Submittal No.: 04c: Containment Plans Rev 2, Pages C8A &C11A

Description: Proposal/Contract Number: Bennington-Mt Tabor BF BPNT (16)
Letting Date: 06/05/15; Award Date: 07/01/15
Project Description: Bridge Painting of Five Bridges
In the Towns of Bennington & Mt. Tabor, VT
Contract Amount: $2,122,323.00; Completion Date: 09/02/16

ABRASIVE BLASTING CONTAINMENT PLANS, REV. 3

SHEET TITLE: CONTAINMENT SECTION DETAILS (3 OF 3)
REF. DWG. NO.:
PROJECT NAME: FIVE BRIDGES ON OR OVER US ROUTE 7
SHEET NO.: C-8A

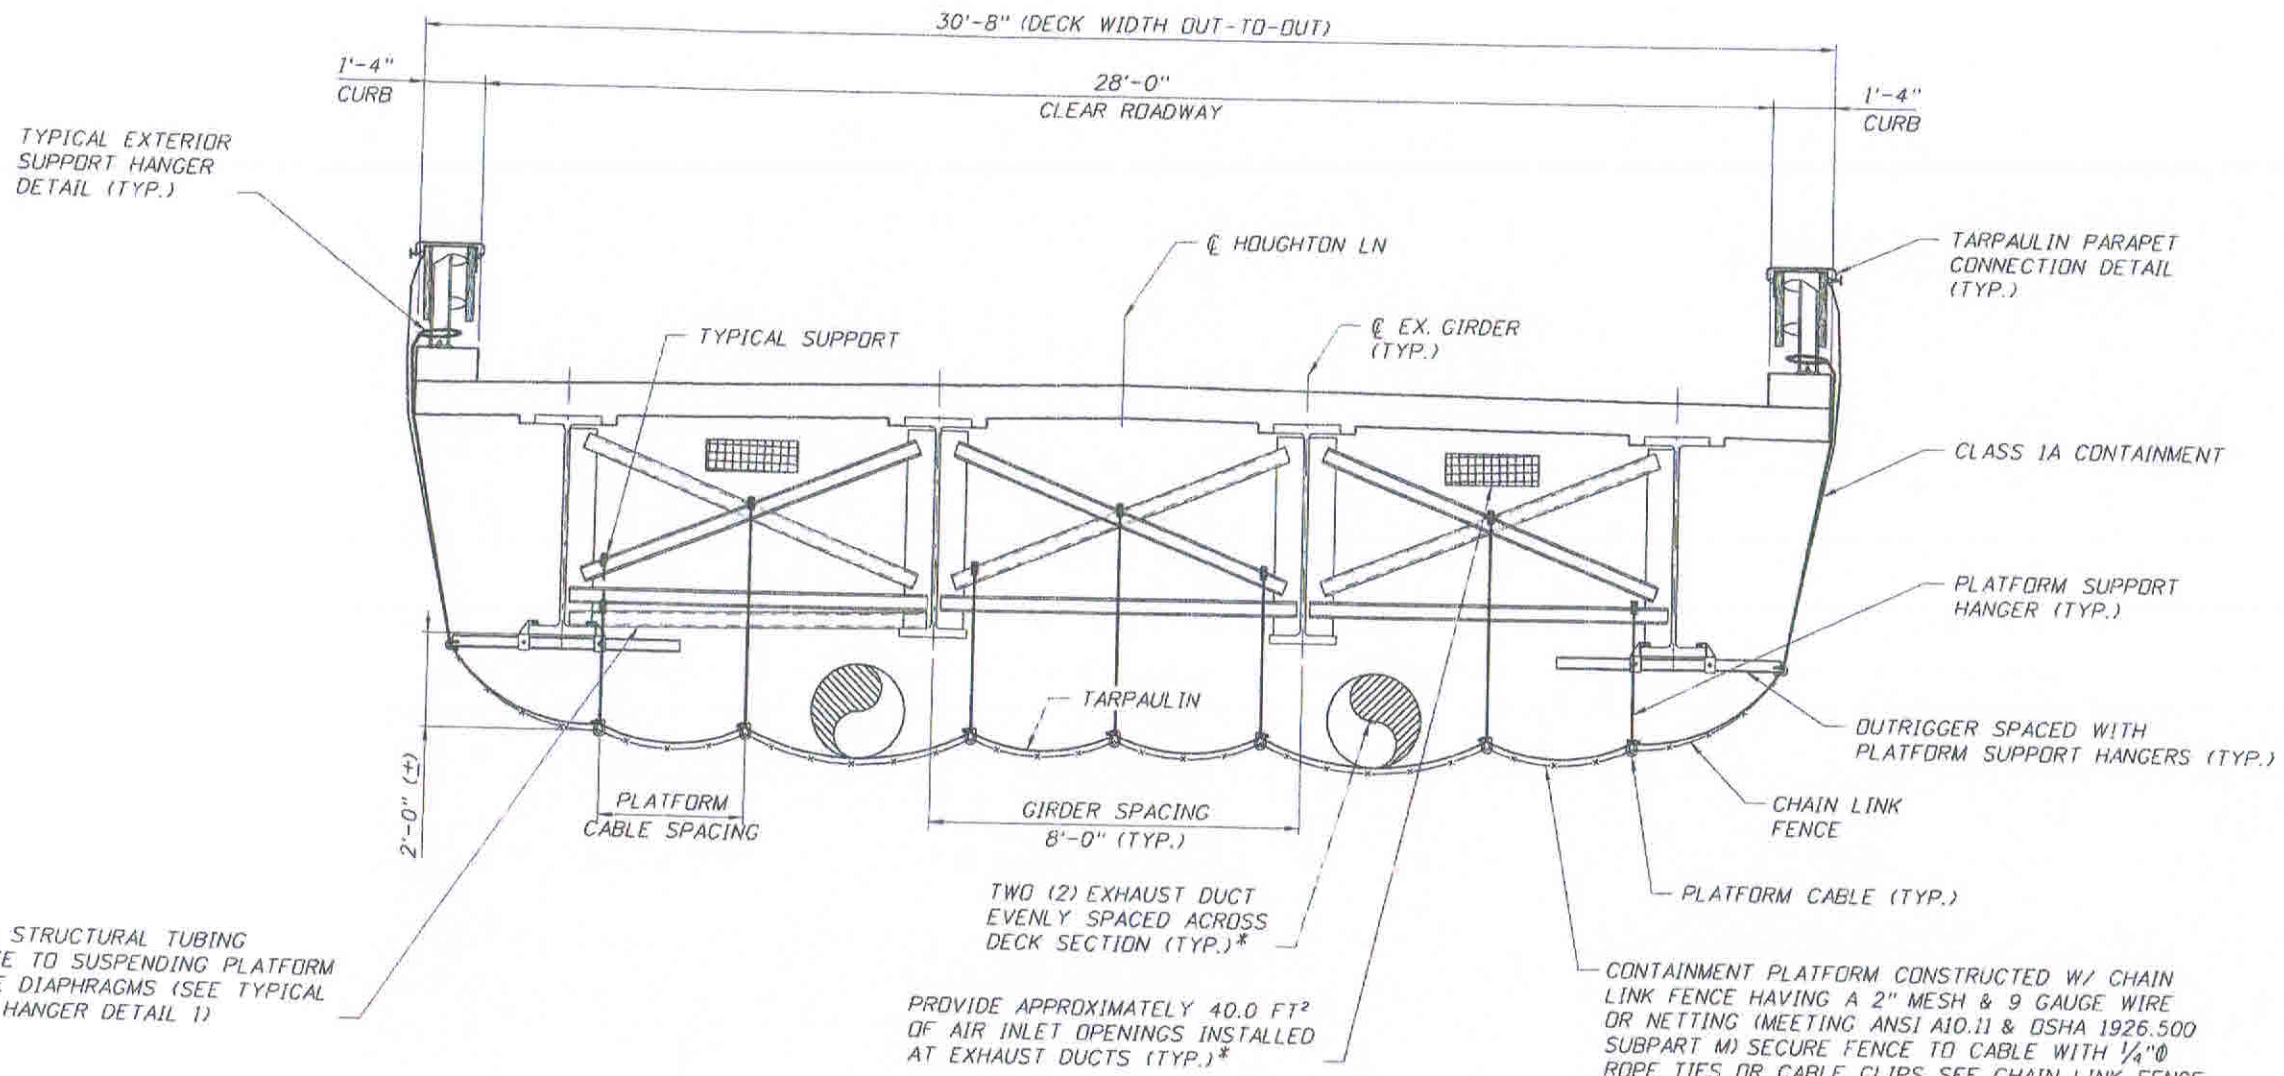
Revision:
We have added the use of fence platform in conjunction with the corrugated platform for bridges 15 and 16N & S. These pages are shown on C8A & C11A. Note that only corrugated platform will be used over live lanes.
